**Substantive response of the Local Highway  
Authority to a planning consultation received  
under The Development Management Order.**

Planning Application Number: 23/01204/REM

Application Address: Land South Of Sketchley Grange Hotel Sketchley Lane Burbage  
Leicestershire

Application for approval of Reserved Matters (relating to layout, scale, appearance and landscaping) of appeal decision APP/K2420/W/22/3301735 (outline planning application 21/01131/OUT) for the provision of 127 dwellings, a substation, public open space, an attenuation pond and associated works

Consideration has therefore been given to Planning Layout drawing number TGDP/SG-BH/PL1 and the Applicant is subsequently advised to consider the following points:

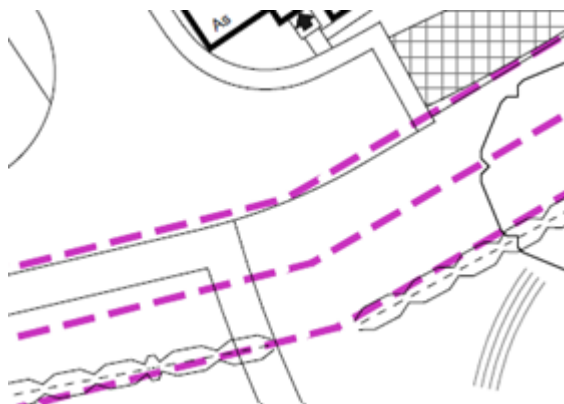
Please clearly identify proposed Access roads, Access ways and any Shared surfaces to be installed on site, including road numbers to aid us with providing design comments.

For clarity, please detail the road, footway and service margin widths that are proposed within this development. The Applicant is advised that 2m footways should be provided on all roads fronting properties except those located on shared surfaces. In addition, the Applicant is required to relocate the footway adjacent to the kerb line and reposition the trees and verges into the curtilage of the adjacent properties. The location of proposed dropped crossing points should also be detailed.

The current design layout fails to provide bend widening in accordance with paragraph 3.33 & Table DG6 of the LHDG.

In addition, a service margin is required to the back of the highway in the location shown below.

A revised plan should be submitted which details 25m visibility splays at all junctions and bends, please note this must be contained within the highway boundary.

The LHA require the Applicants to detail junction radii in accordance with Table DG5 of the LHDG and turning head design in accordance paragraph 3.36 onwards of the LHDG. The Applicants are advised to detail turning head radii and reduce the length of the turning head arms as these are deemed to be excessive in several locations.

The LHA required the scheme to be amended to design speed control into the layout, to maintain a 20mph design speed. Please see section DG4, paragraph 3.48 of the LHDG for further information.

The access to plots 5 to 11 is detailed as a radii access, this requires amending to detail this as a dropped kerb vehicle access point.

The proposed shared surface private drives serving the following plots are considered substandard when compared to the minimum dimensions set out within Figure DG17 of the LHDG and therefore need revision.

- 1 and 2
- 38 and 39
- 43 and 44
- 47 to 49
- 117 and 118

In addition, the LHA are concerned that the width of the proposed drives limit manoeuvring space and therefore raise concerns over the usability of the proposed parking spaces. To address these

concerns, the Applicants should undertake a swept path analysis to demonstrate that a large car is able to access the proposed private drives, manoeuvre, and egress in a forward gear.

The location of the proposed green area fronting plots 79 and 80 affects footway continuity within the development. This should be amended so the internal footway is positioned adjacent to the kerb line and the green area relocated to the back of the highway

Several plots have, private parking bays, located remotely from the front door access points. Experience has shown this type of parking arrangement leads for inconsiderate parking at junctions and on footways. Therefore, the Applicant is advised to review the layout to resolve this issue.

The garages serving plots 14, 26, 27, 85, 101 and 127 are substandard in length and therefore cannot be counted towards the parking provision. Given the above, these plots fall below the minimum parking requirements set out within paragraph 3.151 of the LHDG. The Applicant is advised to review the layout to ensure that adequate parking provision is provided.

The LHA has reviewed the submitted tracking drawings which seek to demonstrate that a Phoenix 2 Duo Recycler (P2-15W with Elite 6x4 chassis). The LHA highlight that the tracking drawings are tight and appear to show several conflict points with the kerb which would not be in the interest of highway safety and could present an unacceptable maintenance burden. Therefore, the Applicant is advised to review the road layout to remove this conflict.
